Access Compliance Report

(Curb Ramps)

Intersection ID: 42505	Main Street: BULLOCK GREENWAY BV	Cross Street: TOLLESON AV	Location:	N
ADA ID: BA978FEC9EE0	Ramp Type: PerpDiag	Initial Pass/Fail: Pass	Overall Compliance: No	Severity Score: 12.5
Codes/Mitigation Info/Possible Solution		Field Measurements/Component Compliance

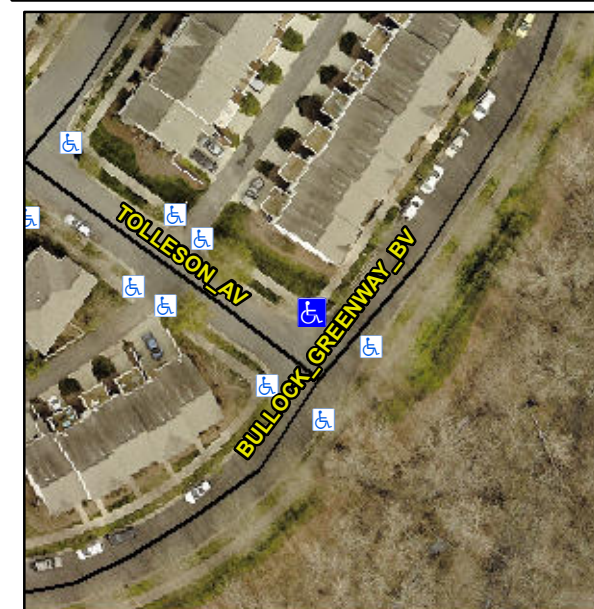
Remove & Replace Curb Ramp With Two New Directional Ramps or Equivalent. Gutter Ponding Observed.

R304.2.2-Perp, R304.3.2-Para, R304.2.3, R305, R302.7

Possible Solutions:
